Economic Commission for Europe**Inland Transport Committee****World Forum for Harmonization of Vehicle Regulations****Working Party on General Safety Provisions****100th session**

Geneva, 11–15 April 2011

Regulation No. 46 (Devices for indirect vision)**Proposal for amendments to
ECE/TRANS/WP.29/GRSG/2010/22****Submitted by the expert from the International Organization of Motor
Vehicle Manufacturers ***

Figure 7
Class IV ~~wide-angle~~ field of vision

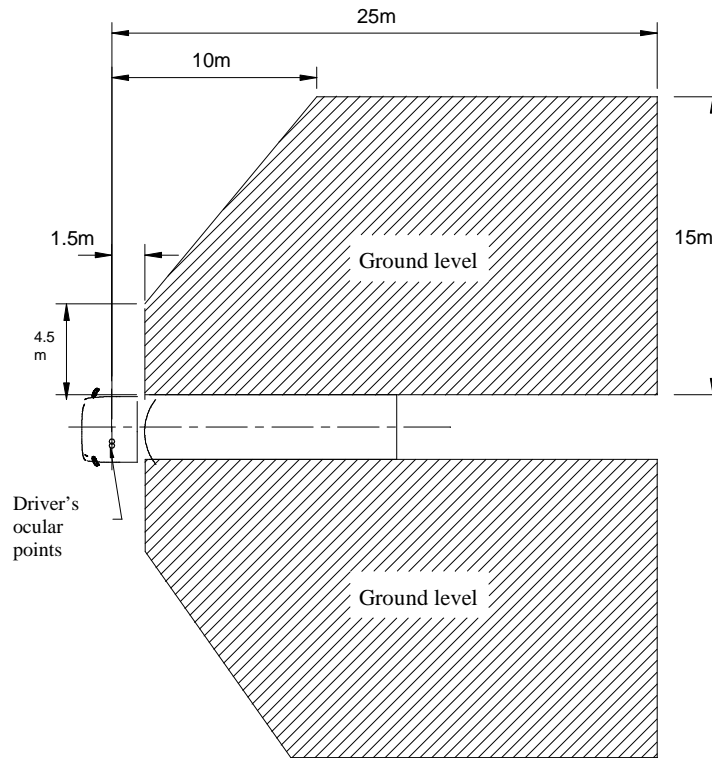
- "15.2.4.4. ~~Wide-angle view device~~ **Class IV field of vision.**
- 15.2.4.4.1. ~~Wide-angle~~ Field of vision on the driver's side.
The field of vision ... driver's ocular points (see Figure 7).
- 15.2.4.4.2. ~~"Wide-angle"~~ Field of vision on the passenger's side.
The field of vision ... driver's ocular points (see Figure 7).
